# UNITED STATES PATENT AND TRADEMARK OFFICE

APPLICATION NO.	FILING DATE	FIRST NAMED INVENTOR	ATTORNEY DOCKET NO.	CONFIRMATION NO.
10/670,524	09/26/2003	Koji Sakiyama	Q77632	6499

<b>Office Action Summary</b>	<b>Application No.</b> 10/670,524	<b>Applicant(s)</b> SAKIYAMA ET AL.	
	<b>Examiner</b> Felix O. Figueroa	<b>Art Unit</b> 2833

## **DETAILED ACTION**

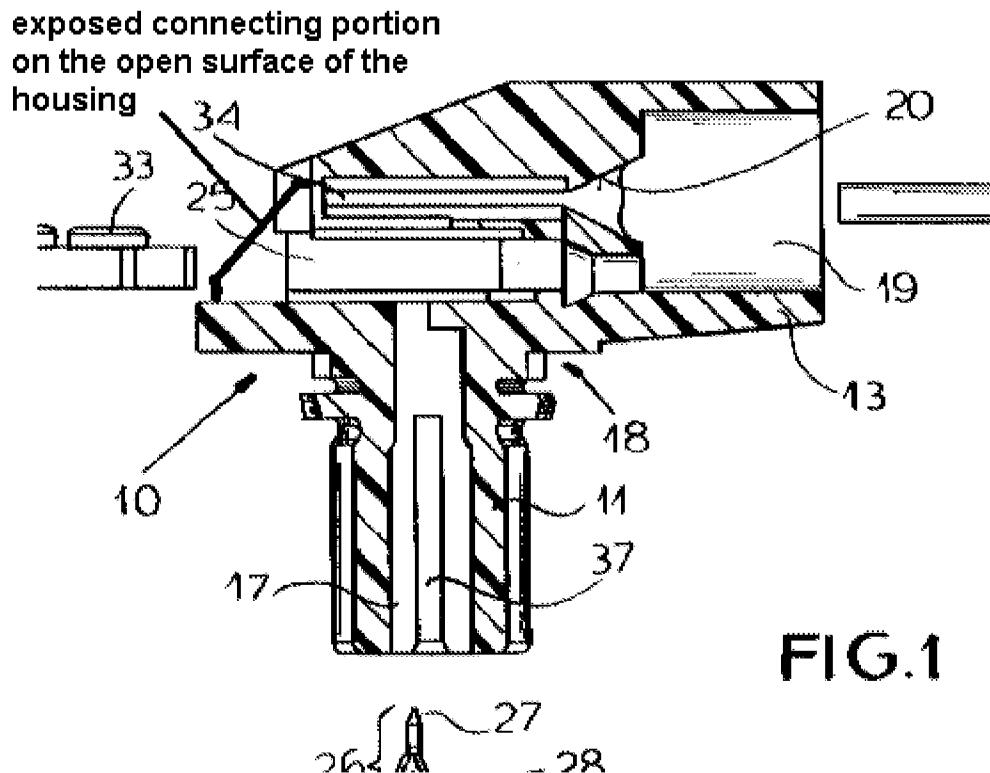
Guss discloses substantially the claimed invention except for the specific exposed connecting portion. Fuchs teaches an exposed connecting portion (see following figure) configure to expose a connection between the discrete connection terminal and at least one conductor of the cable on an outer surface, thus allowing easy insertion of the conductor and visual inspection of the connection between the conductor and the terminal. Therefore, it would have been obvious to a person of ordinary skill in the art at the time the invention was made to form an exposed connecting portion, as taught by Fuchs, to allow easy insertion of the conductor and visual inspection of the connection between the conductor and the terminal.

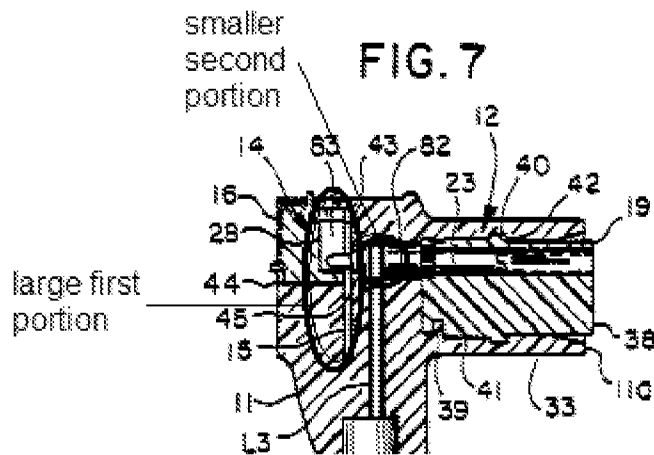
Guss discloses substantially the claimed invention except for the specific exposed connecting portion. Fuchs teaches an exposed connecting portion (see previous figure) configure to expose a connection between the discrete connection terminal and at least one conductor of the cable on an outer surface, thus allowing easy insertion of the conductor and visual inspection of the connection between the conductor and the terminal. Therefore, it would have been obvious to a person of ordinary skill in the art at the time the invention was made to form an exposed connecting portion, as taught by Fuchs, to allow easy insertion of the conductor and visual inspection of the connection between the conductor and the terminal.

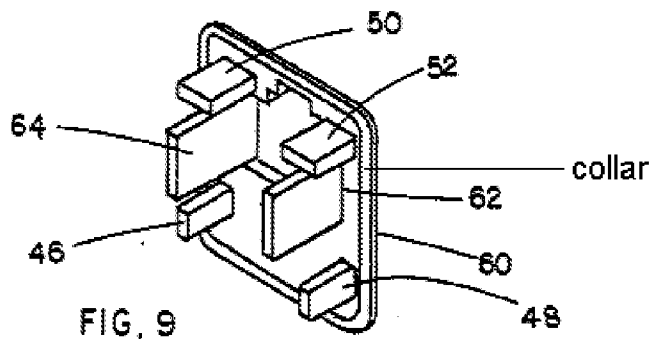
Guss, as modified by Fuchs, discloses substantially the claimed invention (see discussion on claims 1 and 3) except for the receiving member and the retainer. Arnett teaches a mounting structure for an auxiliary machinery / connector (60) directly coupled to a plurality of conductors (not labeled), mounted to a receiving member (22) with a mounting hole (24); wherein the distal end (right of 60 on Fig.2) of the housing

can engage the mounting hole; and a retainer (30) that attaches to the distal end of the housing and an outer periphery (at 32) of which engages in the mounting hole of the receiving member; wherein the auxiliary machinery is mounted to the receiving member by attaching the retainer in the mounting hole from one side of the receiving member (right side), and attaching the housing to the retainer from the other side of the receiving member (left side) to securely mount the auxiliary machinery onto a predetermined usage/working location (see abstract lines 22-26). Therefore, it would have been obvious to a person of ordinary skill in the art at the time the invention was made to mount the auxiliary machinery of Fuchs on a receiving member, as taught by Arnett, to securely mount the auxiliary machinery onto a predetermined usage/working location.
